## SUMMARY OF GREEN BUILDING SUBMITTAL

La Quinta Inn & Suites  
8300 John Carpenter Freeway  
Dallas, TX  
Permit # 089080

**ADDENDUM 1**

This addendum becomes part of Construction Drawings.

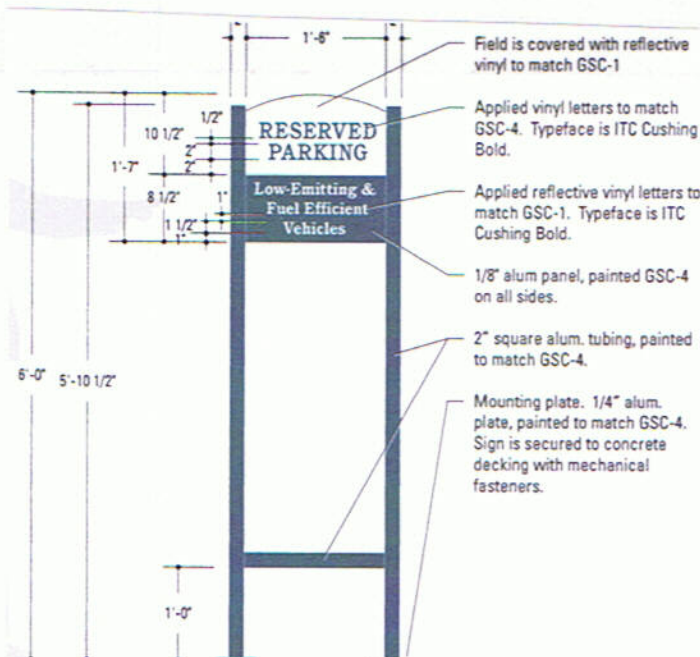
- Item #3 Refer drawing below for addition of recycling room at dumpster area.
- Item #4 Provide urinals with 0.5 gallons per flush at all urinals  
Provide Dual Flush Valve Toilets – 1.6/1.1 gallons per flush at all toilets  
Provide low flow aerated faucets at all guestroom and bathroom faucets  
Per instructions: use of all required fixtures should approximate 40% water savings. We are replacing more than 68% of the fixtures (toilets, faucets and urinals) with water conserving features (we are not replacing showerheads). Therefore we approximate greater than 20% reduction.
